CNL-16-093

Subject: **Proposed Technical Specifications (TS) Change TS-505 - Request for License Amendments - Extended Power Uprate (EPU) - Supplement 19, Responses to Requests for Additional Information**

**Responses to NRC Electrical Engineering Branch Requests for Additional Information EEEB-
RAIs 5 through 25**

Figure EEEB-RAI 7-1

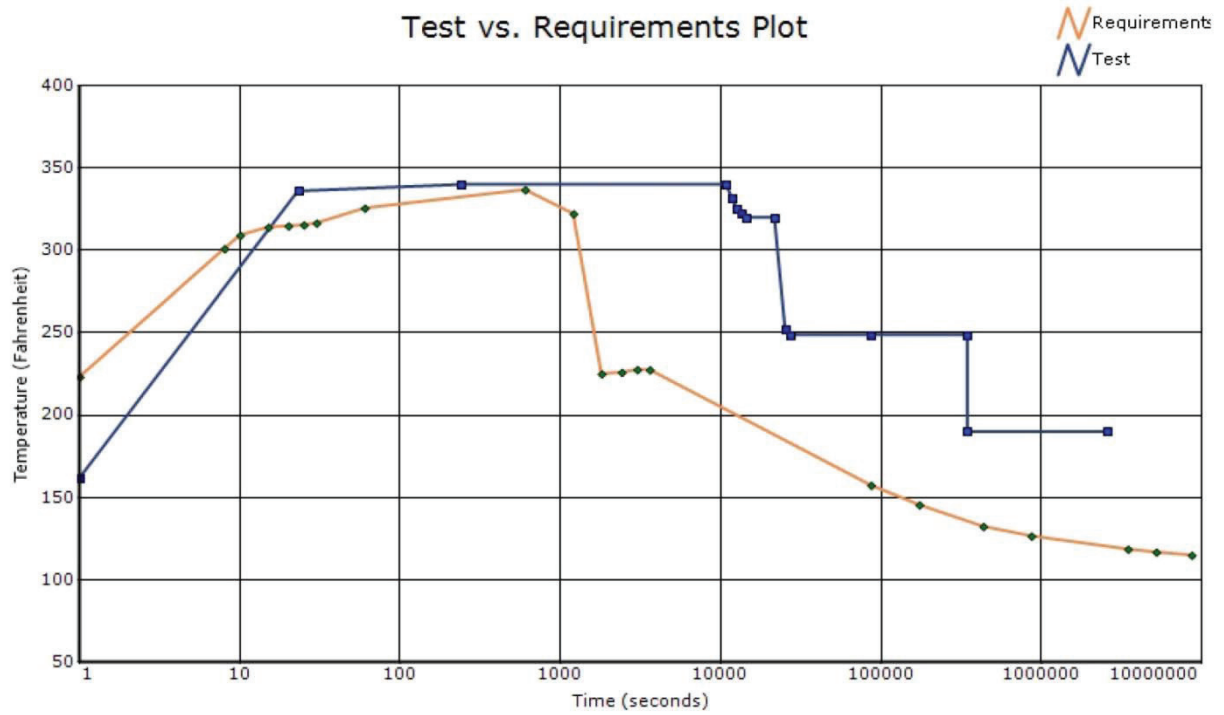
Provide the current component qualification temperature profile of EQ electrical equipment (considering the qualified temperature of worst case components) inside primary containment to confirm that it bounds the EPU drywell temperature profile shown in Figure 2.3-1. Also, discuss how the temperature margins in the Institute for Electrical and Electronics Engineers Standard 323-1974 will be maintained under EPU conditions.

Although Figure 2.3-1 of Attachment 7 of the BFN LAR shows that the EPU drywell profile exceeds the CLTP drywell profile, the individual component qualification temperature testing still bounds the EPU drywell temperature profile. Note 1 of Table 2.3-1 states that "Current component qualification testing bounds the temperature increase." This statement is based on the result of accident degradation equivalency (ADE) calculations which support that the current component qualification testing exceeds the EPU drywell temperature profile. This is an industry accepted method of comparing the test and plant accident temperature profiles to demonstrate acceptable post-accident qualification.

Figure EEEB-RAI 18-1 (This figure is applicable to all Unit 1, 2, and 3 4KV Unit Boards)

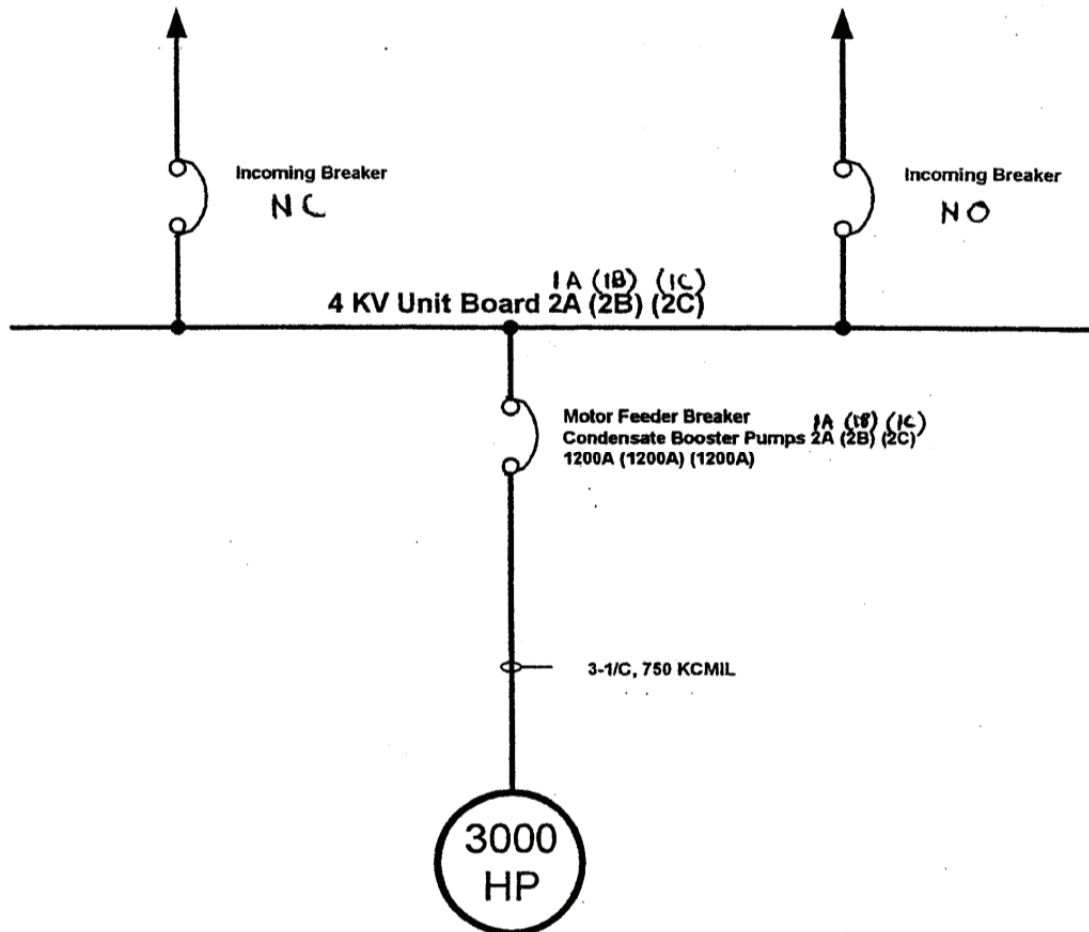
- a. Identify the balance of plant buses/boards that power the CPs and CBPs, and provide the worst case loading of these buses/boards and margin available at CLTP and EPU conditions. Also, provide a copy of all the Single Line Diagrams listed on page E5-5 provided in response to EEEB-RAI-2.*
- b. Provide a summary of relay settings to show that CBPs and their associated boards remain adequately protected during transient loading. Also, provide a duration of the transient loading.*

Figure EEEB-RAI 18-1 provides a schematic of the normal and alternate board feeds and the CBP motor feed.
